**Subject: P.H.O. APPLICATION NO. PHO-1-24--Z-22-23-4 – Notice of Pending Actions by the Planning Hearing Officer**

APPLICATION NO: PHO-1-24--Z-22-23-4

**Reason for Request:** Request to modify Stipulation 16 regarding landscape area.; Request to delete Stipulation 18 regarding right-of-way dedication for 8th Street.

A ENLARGED SITE PLAN  
SCALE: 1"=10'

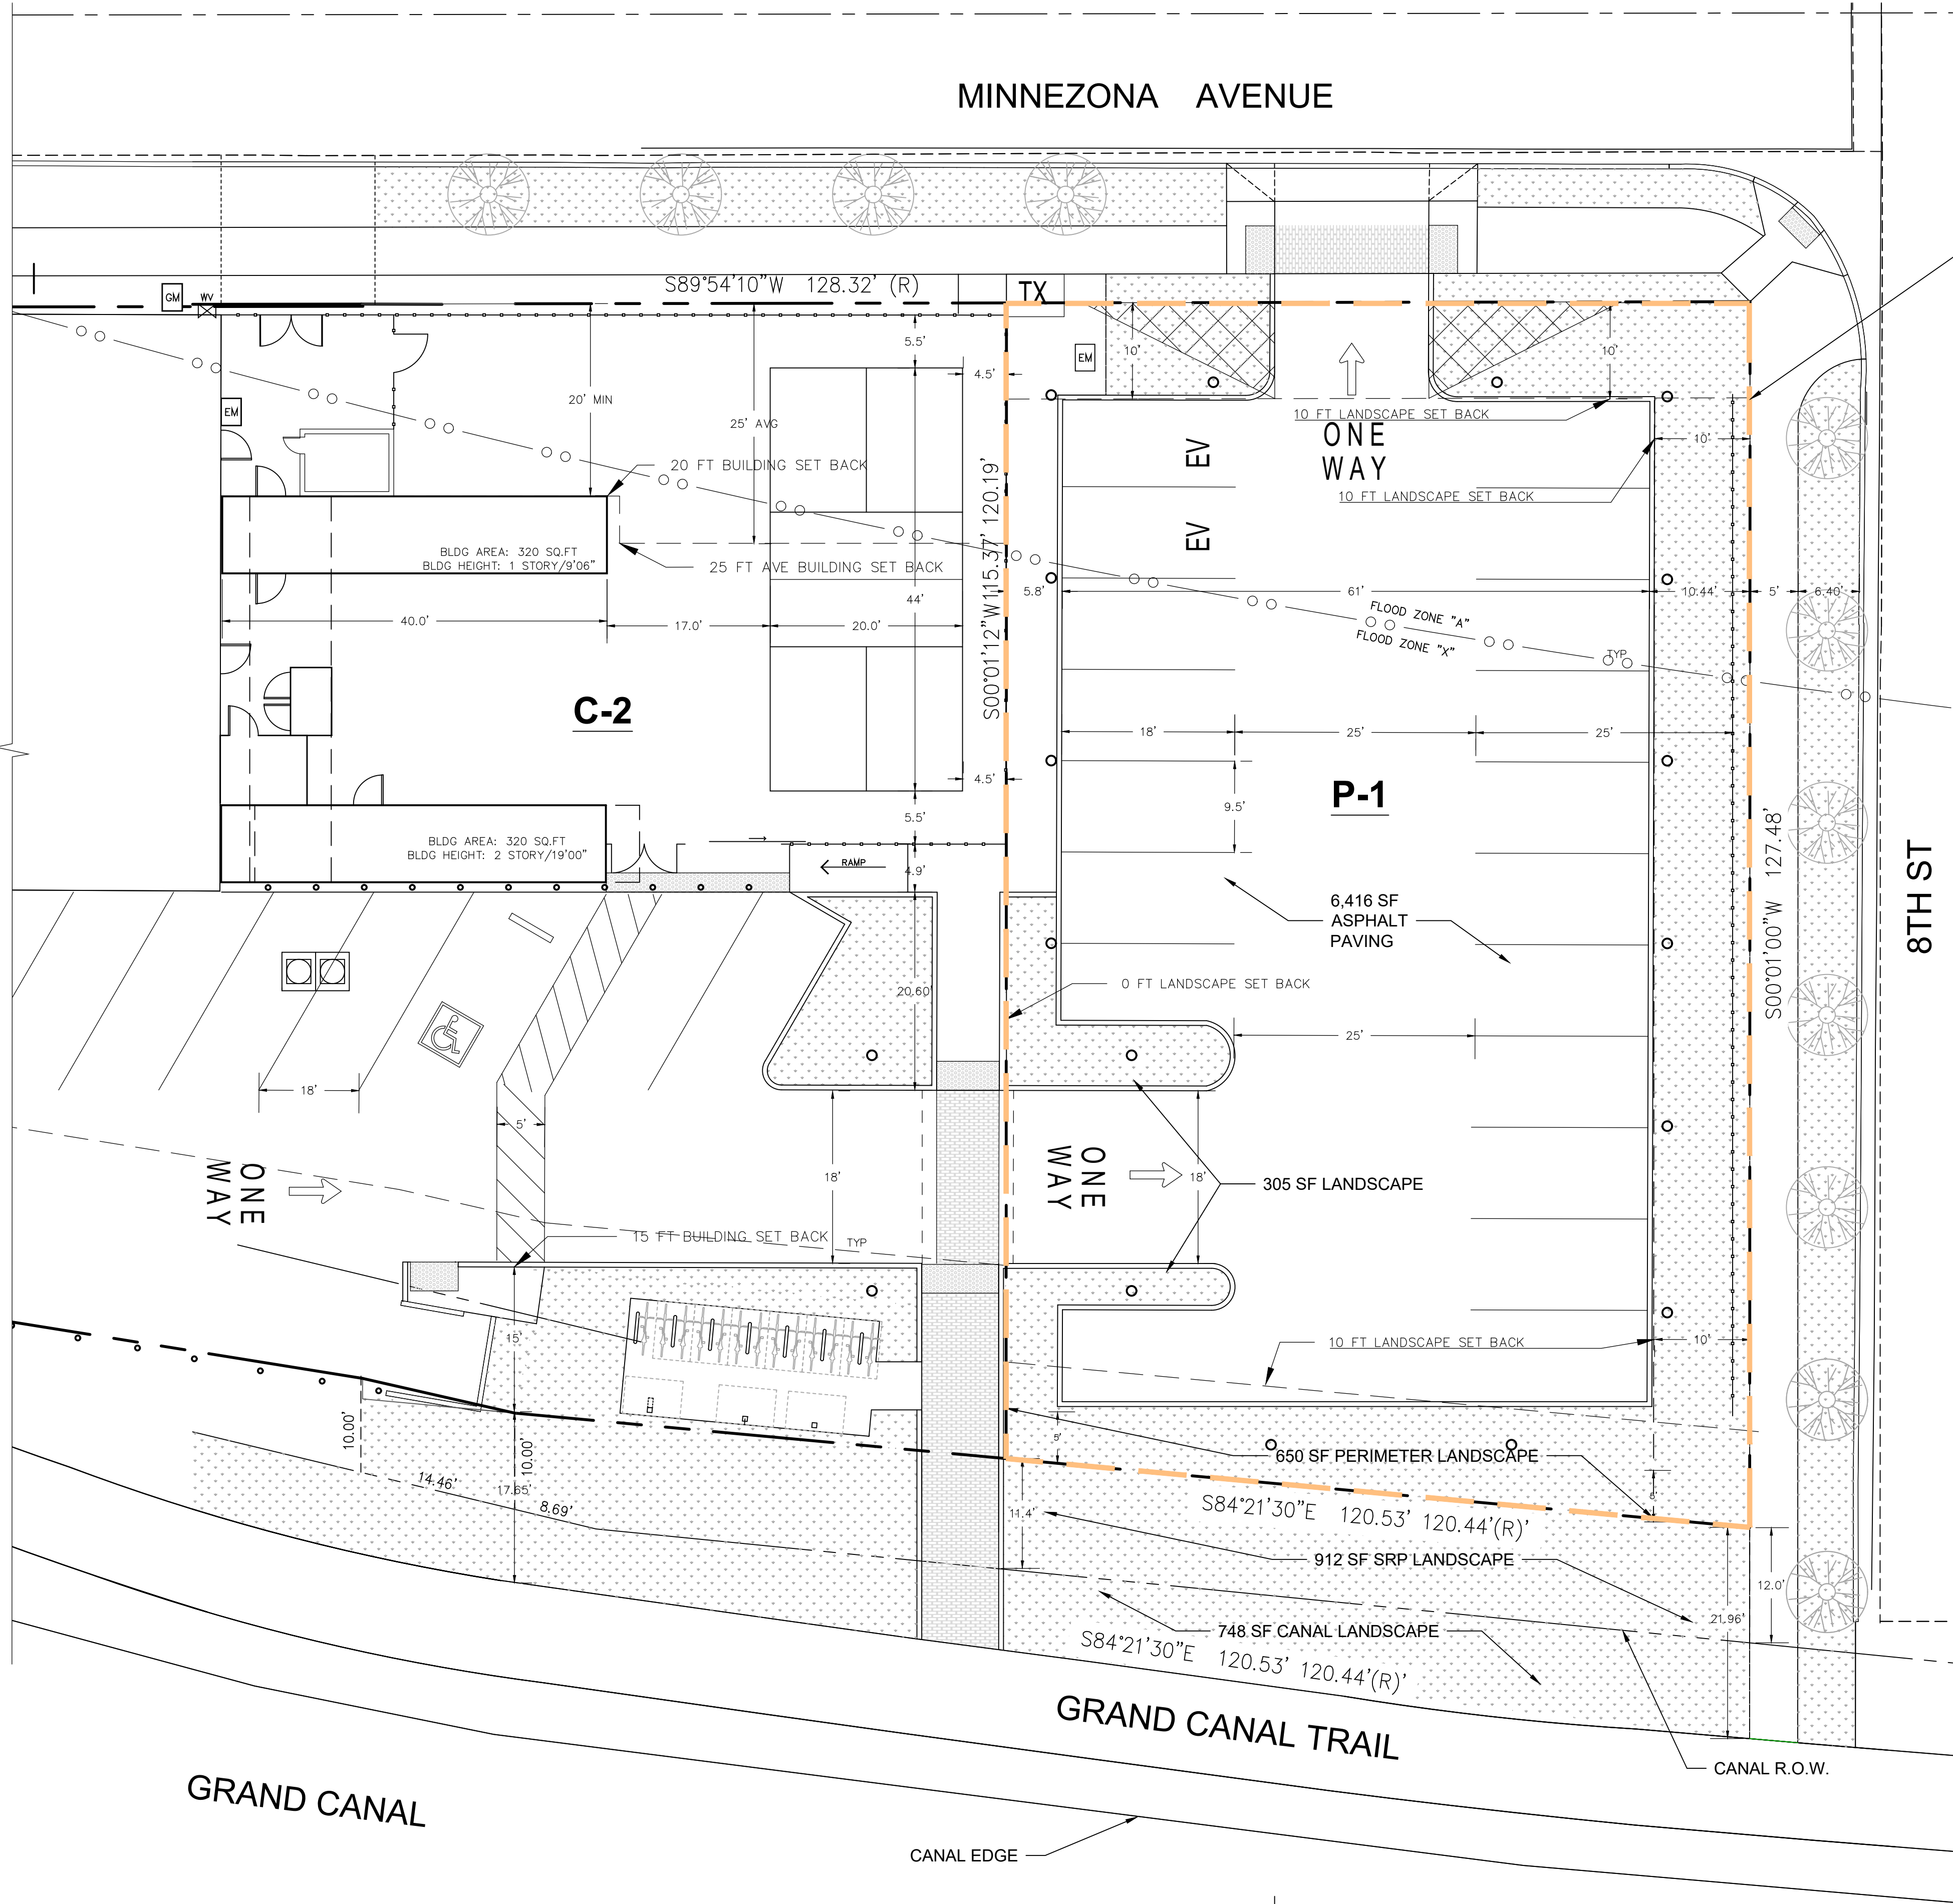
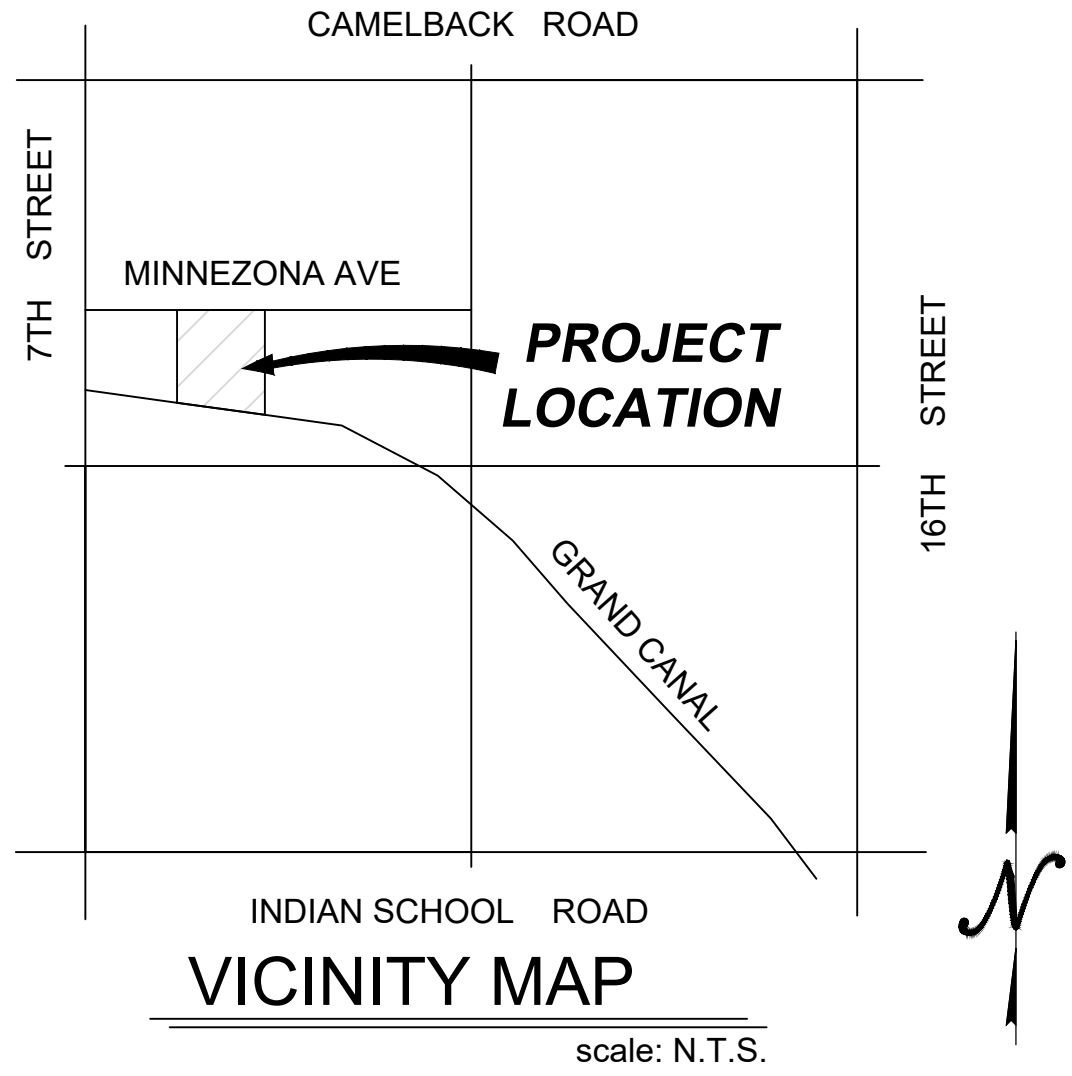
- 16. A minimum 5, average 10-foot-wide landscape ~~setback~~ **area** shall be provided from the south property line.

It is requested that stipulation 16 be modified to a landscape requirement that is not classified as a "setback" due to the extreme limitations placed upon landscape setbacks for development. It must be noted that the applicant is not opposed to providing landscape, but is promoting that the landscape count towards meeting stipulation 17 and other site development requirements required.

~~18. Right-of-way shall be dedicated for the west half of 8<sup>th</sup> Street for a half-radius 45-foot radius cul-de-sac dedication at its southern termination.~~

There is concern that Stipulation 18 does not appear feasible and conflicts with stipulations 14, 15, and 16.

The dedication will not only negatively impact the design of a sensible parking lot in P-1, but the actual completion of a 90' diameter cul-de-sac presents a major impact to the residents on the east side of 8<sup>th</sup> Street if it were to be built (See Enclosure 2). The city currently does not have a dedication of the other 45' half-radius required from the three lots to the east of 8<sup>th</sup> Street.

Furthermore, the cul-de-sac dedication at the termination of 8<sup>th</sup> street presents a conflict with property rights of the Salt River Project (SRP) who own the southern sliver of land. Enclosure 3, Sheet 2 shows that a portion of the requested

dedication will encroach on SRP property to include city improvements around the cul-de-sac.

It is proposed that this stipulation be deleted contingent upon the lot-line adjustment and replat to bring 8<sup>th</sup> Street in conformance with a maximum of 4 total lots on a dead-end street.
